MIRROR/WINDOW CONTROLLER

SERVICE BULLETIN

(Tollway Defeat)

Intellitec part No# 00-00292-100, 00-00292-200 and 00-00368-000
Fleetwood part No# F22-2096, F22-8000 and F22-2098

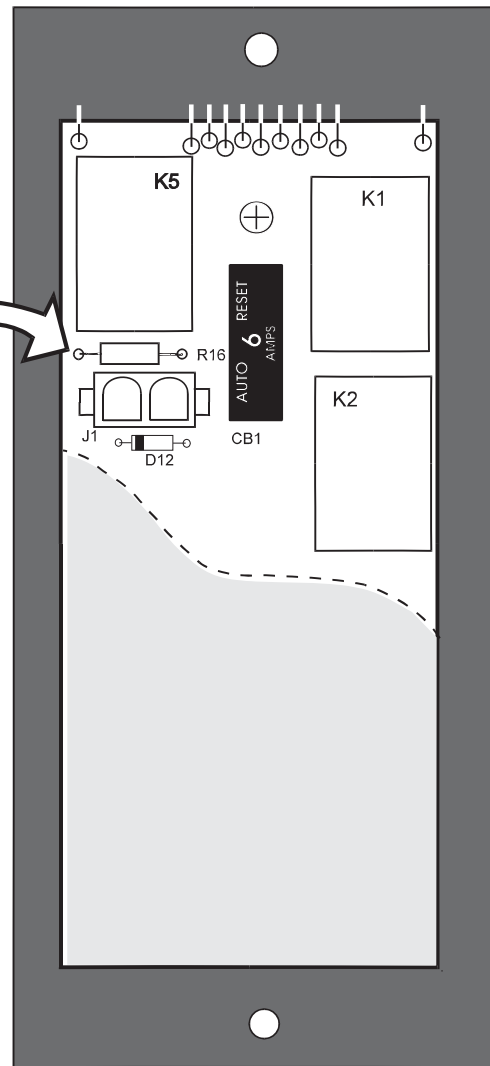
To defeat the Tollway feature, cut leg of resistor marked R16, a 220 ohm resistor, from the unit

Note: Only one end of the resistor need be cut.

*Cut R16 to defeat
Tollway feature.*
